Access Compliance Report

Public Rights-of-Way (Curb Ramps)

Intersection ID: 2890	Main Street: BROKEN_PINE_LN	Cross Street: EVERGREEN_HOLLOW_DR	Location: SE
ADA ID: E3ACE9130067	Ramp Type: Perp	Initial Pass/Fail: Fail	Overall Compliance: No
Codes/Mitigation Info/Possible Solution		Field Measurements/Component Compliance

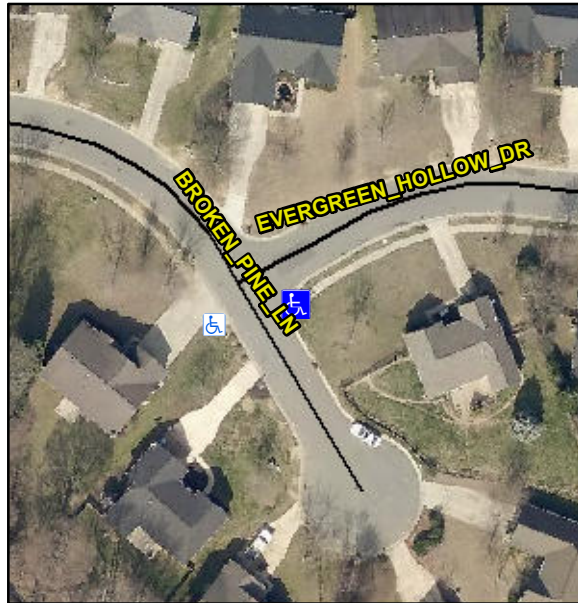
Not Found, R304.5.1, R304.2.2, R304.5.3

Compliance	Description	Data	Compliance	Description	Data
N/A	Ramp Length (in)	50.0	No	Ramp Slope (%)	13.5
No	Ramp Width (in)	36.0	No	Ramp XSlope (%)	5.4
N/A	Flare Type LT	N/A	N/A	Flare Type RT	N/A
N/A	Flare Slope LT (%)	N/A	N/A	Flare Slope RT (%)	N/A
N/A	Flare Traversable LT?	N/A	N/A	Flare Traversable RT?	N/A
N/A	Landing Length (in)	N/A	N/A	DWS Provided?	N/A
N/A	Landing Width (in)	N/A	N/A	DWS Contrast?	N/A
N/A	Landing Slope (%)	N/A	N/A	DWS Length (in)	N/A
N/A	Landing X Slope (%)	N/A	N/A	DWS Full Width?	N/A
N/A	Landing Curb? (Y/N)	N/A	N/A	DWS Offset (in)	N/A
N/A	Shared Landing?	N/A			
N/A	Gutter Ponding?	N/A	N/A	Gutter Slope (%)	N/A
N/A	Gutter Lip Ht (in)	N/A	N/A	Gutter X Slope (%)	N/A
N/A	Painted X Walk1?	No	N/A	Painted X Walk2?	N/A
	X Walk 1 Direction	To W		X Walk 2 Direction	N/A
N/A	X Walk 1 Width (in)	N/A	N/A	X Walk 2 Width (in)	N/A
	X Walk 1 Slope (%)	5.1		X Walk 2 Slope (%)	N/A
	X Walk 1 X Slope (%)	3.0		X Walk 2 X Slope (%)	N/A

Remove & Replace Entire Ramp.
